TECHNICAL SPECIFICATIONS CHANGES

INCREASED FQ(Z) WITH 18% STEAM GENERATOR TUBE PLUGGING

NORTH ANNA UNITS 1 AND 2

Figure 3.2-2 NORMALIZED $FQ(z)$ AS A FUNCTION OF CORE HEIGHT

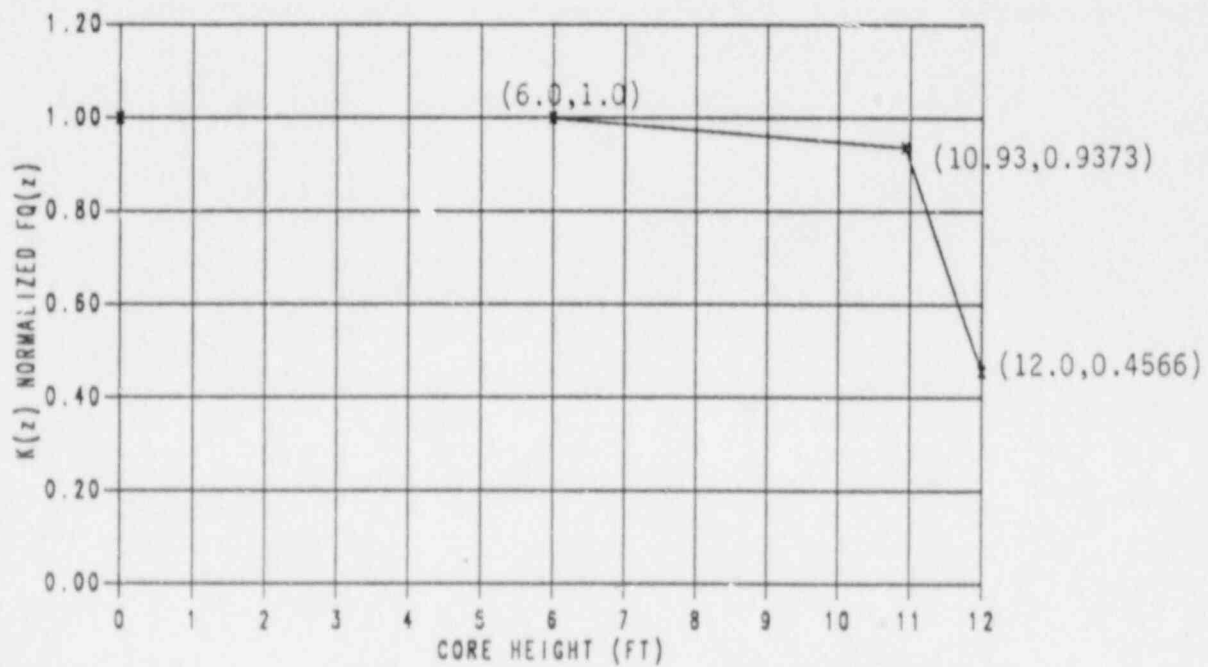
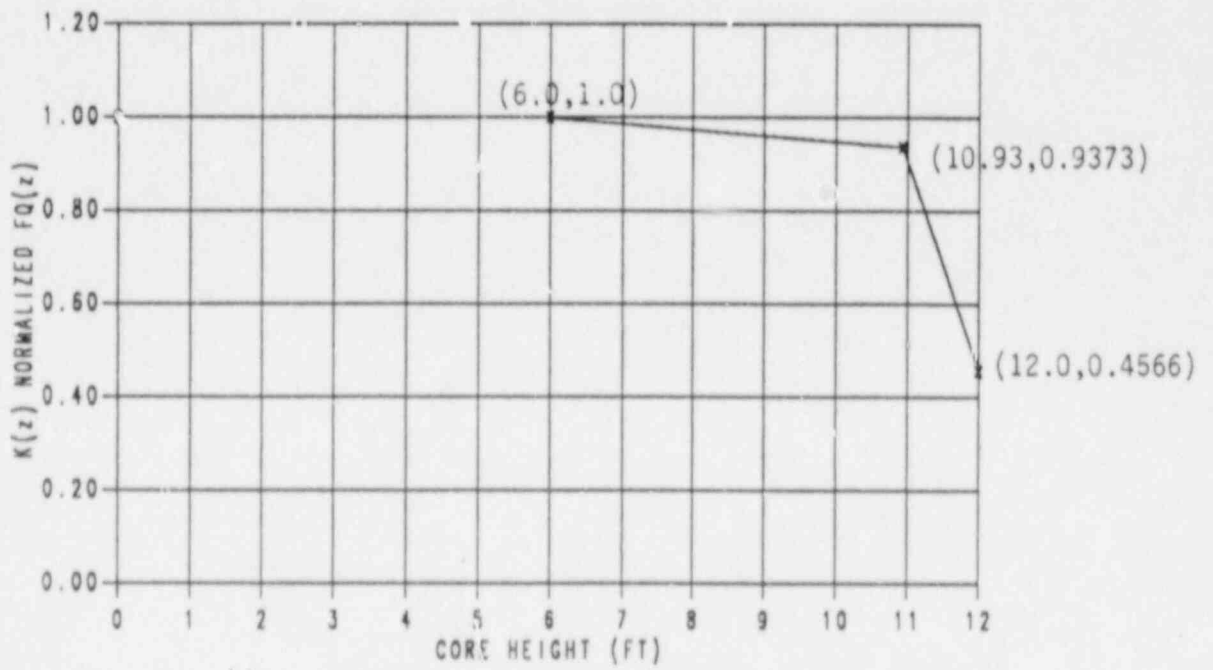
3.2.2 $F_Q(Z)$ shall be limited by the following relationships:

$$F_Q(Z) \leq \frac{[2.19]}{P} [K(Z)] \text{ for } P > 0.5$$

$$F_Q(Z) \leq [4.38] [K(Z)] \text{ for } P \leq 0.5$$

and $K(Z)$ is the function obtained from Figure 3.2-2 for a given core height location.

$$F_Q(Z) \leq \frac{[2.19]}{P} [K(Z)] \text{ for } P > 0.5$$

$$F_Q(Z) \leq [4.38] [K(Z)] \text{ for } P \leq 0.5$$

and $K(Z)$ is the function obtained from Figure 3.2-2 for a given core height location.
